Ministry of the Environment,
Conservation and Parks
Floor 1, 135 St Clair Ave W
Toronto, ON
M4V 1P5
Telephone: (416) 314-8310

August 16, 2019

**Re: Condition A9 and requirements in Schedule C of your REA
Renewable Energy Approval # 0871-AV3TFM (Approval)
Nation Rise Wind Farm
Cornwall City, United Counties of Stormont, Dundas and Glengarry
Reference Number 6695-APKGUB**

Table 1: 2019 Project substation barrier coordinates vs Approval barrier Coordinates

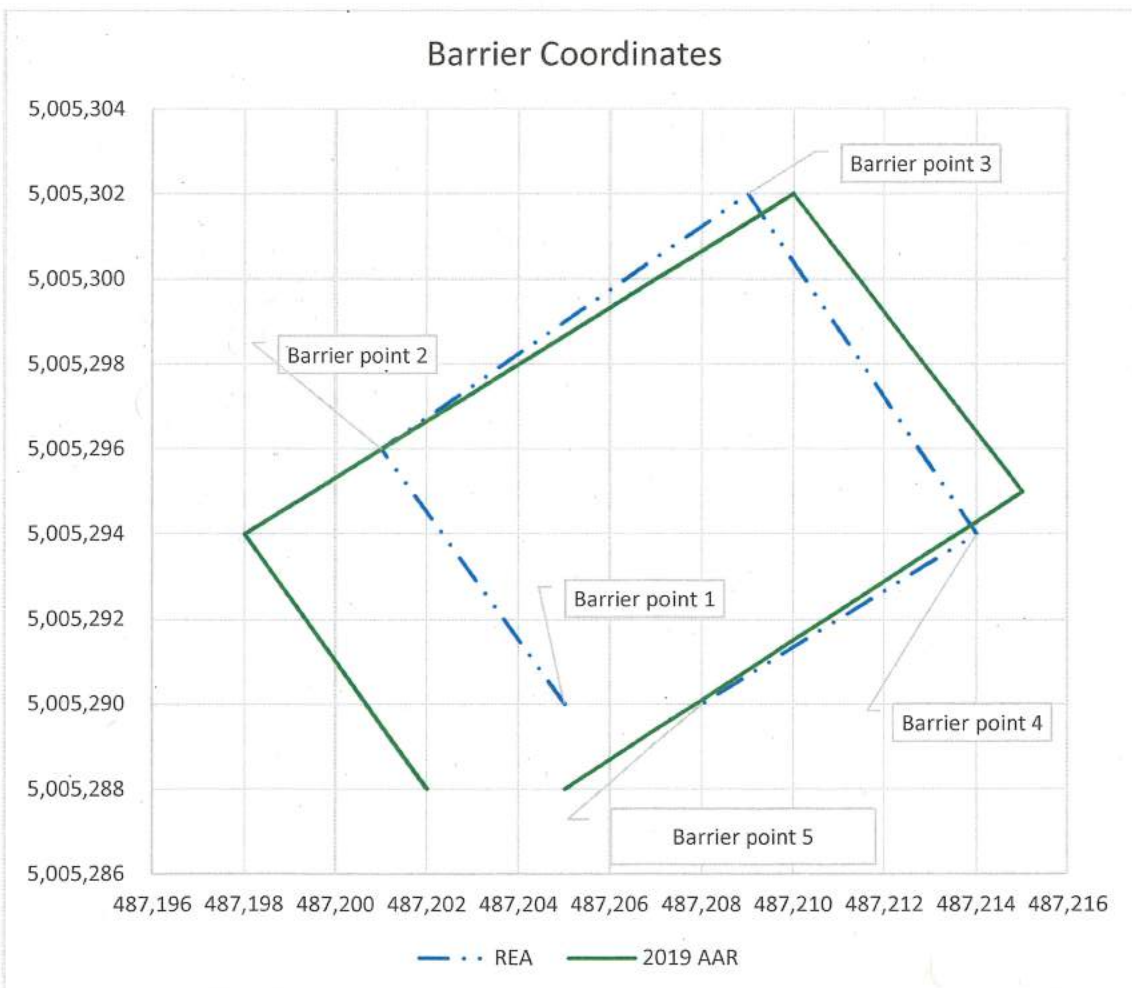
- a. the equivalent turbine is an Enercon E-138 EP3, 3.44 MW (Mode NR2) turbine (*refer to Annex*), and
- b. the selected transformer substation has a sound power level of 101.7 dBA as opposed to 109.9 dBA noted in the Approval. Furthermore, in accordance with provisions in Schedule C of the Approval minor adjustments to the barriers positioning were noted and accounted for to the satisfaction of the ministry. (*Refer to Annex 5*).

A sound barrier is planned for the Project substation transformer. The type of barrier used in the (2019) noise study is one that can be described as of absorptive type with an Absorptive Coefficient of at least 0.8.

The acoustic barriers will have a surface density of at least 20 kg/m^2 and have a closed surface free of gaps and cracks. A four-sided barrier was modeled with heights ranging from 5 m to 6.05 m. The total barrier linear length is approximately 42 m. The following tables provide details of the substation and acoustic barrier.
